RESOLUTION SETTING HEARING ON REQUEST FROM J LARSON HOMES, LLC TO AMEND PUD CONCEPTUAL PLAN FOR PROPERTY LOCATED IN THE VICINITY OF 3001 BLOCK OF EAST ARMY POST ROAD

(ZON2019-00133)

P.U.D. CONCEPT PLAN

THREE LAKES ESTATES II

PROPOSED PUD

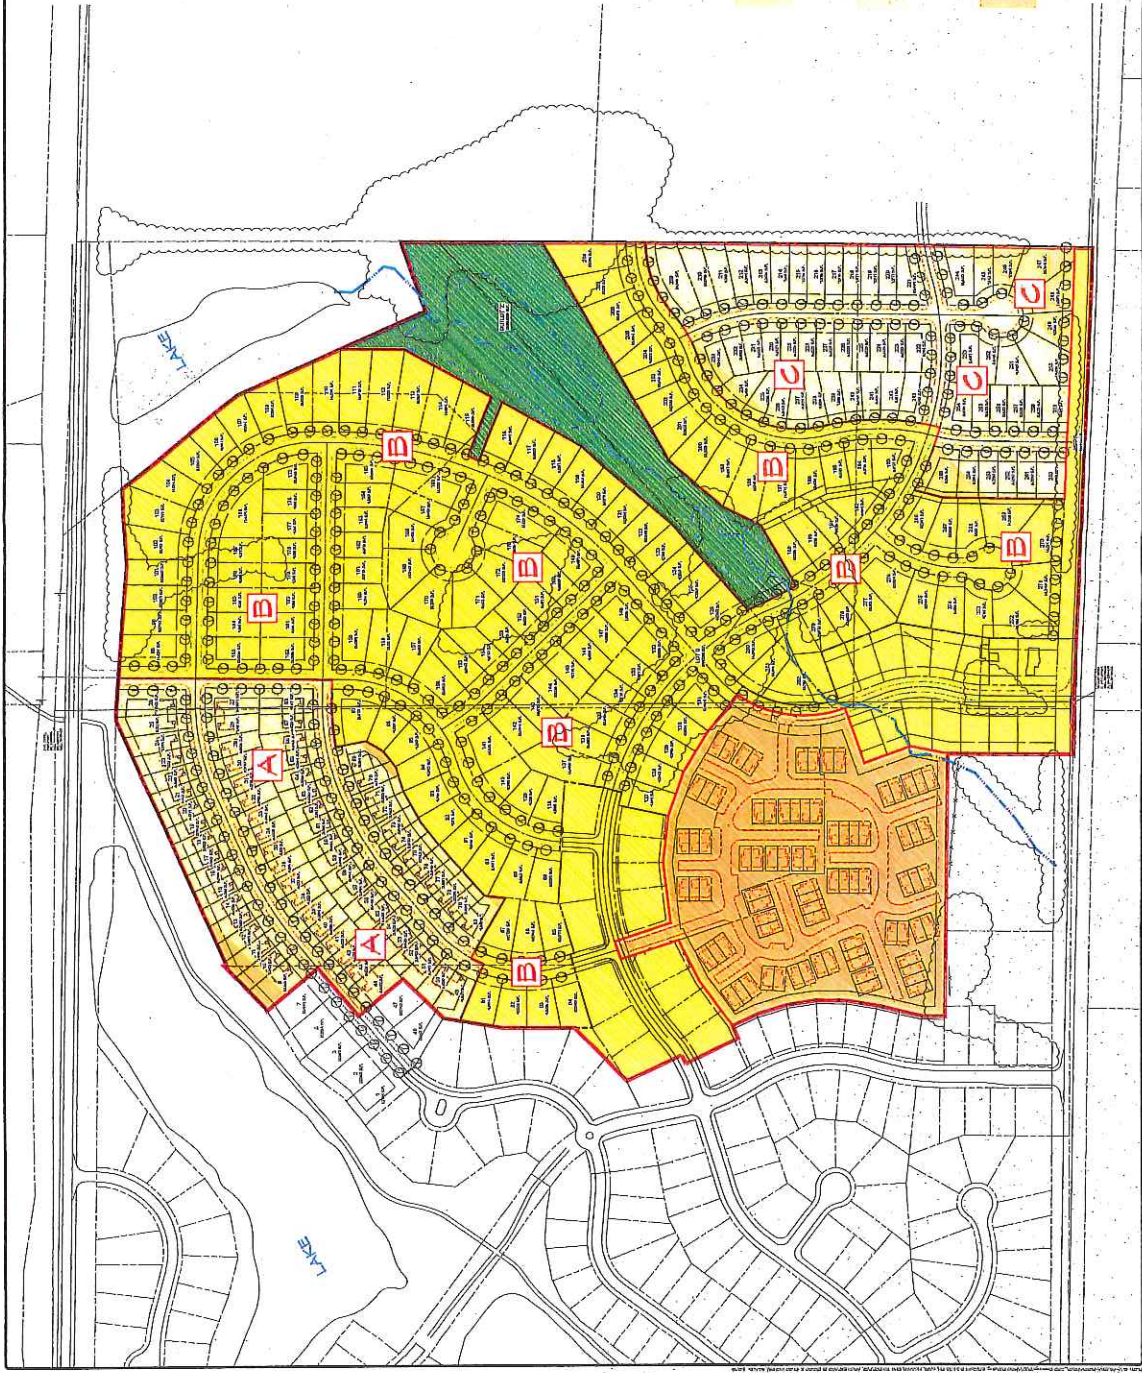
APPROVAL of the submitted PUD Conceptual Plan amendment subject to the following revisions:

- 1) Compliance with all administrative comments for final Mylar submittal.
- 2) Addition of a note on the Plan that any development of the Property must comply with the Tree Removal and Mitigation Ordinance contained in Chapter 42, Article X, of the City Code.

- 3) Revision to the note to require all public sidewalks to be 5-feet in width.
- 4) Revision of the fence allowance note to also allow up to a 6-foot tall solid wood fence in rear yards and along the frontages of East Army Post and East Pine Avenue for lots that have rear yards abutting those streets.

- 5) Revision to the notes on the Plan to provide the following requirements for single-family and single-family semi-detached dwellings:
 - A) No same single-family or single-family semi-detached house front elevations shall be built on adjacent lots.

- B) The front façade of any single-family or single-family semi-detached house constructed must contain one of the following:
 - i. A front porch of not less than 60 square feet; or

- ii. Stone or brick masonry siding covering at least 1/3 of the façade.
 - C) All windows and doors on any single-family or single-family semi-detached house shall have trim that is no less than 4 nominal inches in width.

- D) The roof on any single-family or single-family semi-detached house constructed shall be of asphalt type shingles or cedar shakes. Standard 3-tab shingles are prohibited.

- E) On single-family lot sizes less than 65 feet in width the following minimum house sizes shall be constructed:
 - i. Any 1-story house shall be constructed with a minimum of 1,250 square feet of above-grade finished floor area.

- ii. Any 1-½-story house shall be constructed with a minimum of 1,350 square feet of above-grade finished floor area.
 - iii. Any 2-story house shall be constructed with a minimum of 1,400 square feet of above-grade finished floor area.

- F) On single-family lot sizes 65 feet in width or greater the following minimum house sizes shall be constructed.
 - i. Any 1-story house shall be constructed with a minimum of 1,400 square feet of above-grade finished floor area.

- ii. Any 1-½-story house shall be constructed with a minimum of 1,600 square feet of above-grade finished floor area.
 - iii. Any 2-story house shall be constructed with a minimum of 1,800 square feet of above-grade finished floor area.

- G) Exterior material for any single-family or single-family semi-detached house constructed shall be masonry (brick or stone), vinyl of no less than 0.042 thickness, cedar, masonite, or cement fiber board.

- H) For any single-family semi-detached dwellings, a brick or stone wainscot should extend along the full side façade on those units where the side faces a public street.

- I) Building elevations for the Conceptual Plan shall be required to be revised to demonstrate compliance with these provisions.
